The following is an excerpt from the book Post-disaster shelter: 10 Designs, IFRC, 2013. Inclusion of this design is for information purposes and does not necessarily imply best practice. Designs are site specific.

Assessments were conducted against hazard data for each location by structural engineers using the International Building Code (IBC) 2012, and National Building Codes as applicable.

# B.10 Sri Lanka – 2007 – 'Core Shelter'

## Roof Framing Plan

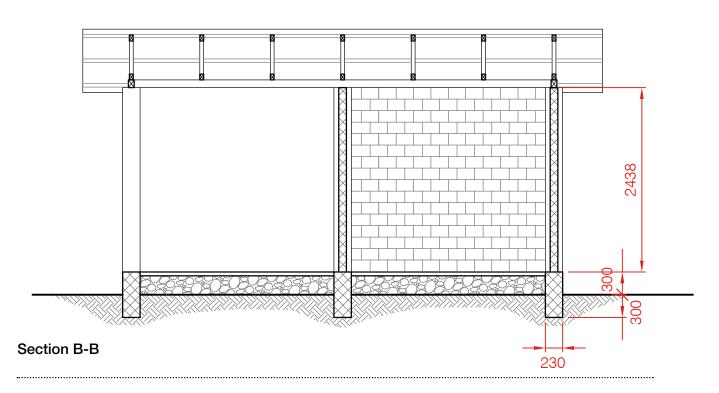
The construction materials used for this shelter are of high quality and very durable, and can provide a shelter with a long design life. While the materials themselves are durable, the wall thickness and wood member dimensions are not sufficient to resist the wind pressures from a full storm, but performance of the structural system under the anticipated seismic loads is acceptable. The simplest solutions for the performance under wind load are to either evacuate the shelter during a storm, or to increase the size of the walls and roof framing.

The single width unreinforced brick walls are capable of resisting the expected seismic loads, but are not sufficient for the expected effects of a typhoon. If the walls fail, the falling brick could injure any occupants. In addition, depending on the grade and quality of the coconut wood, the wood framing may not be capable of resisting the expected uplift pressures from the storm winds. Proper site analysis is necessary prior to construction to determine appropriate finished floor heights to provide any mitigation of flood hazards.

To improve the resistance to wind loads, the exterior walls can be increased to two widths thick. In addition, the wall sections between piers should be positively attached to the wall top plate to prevent the top of the wall from deflecting.

The veranda can be converted into enclosed space by bricking in between the piers. In this situation, it is important that the interior wall down the middle remain in place to support the ridge beam in the roof.
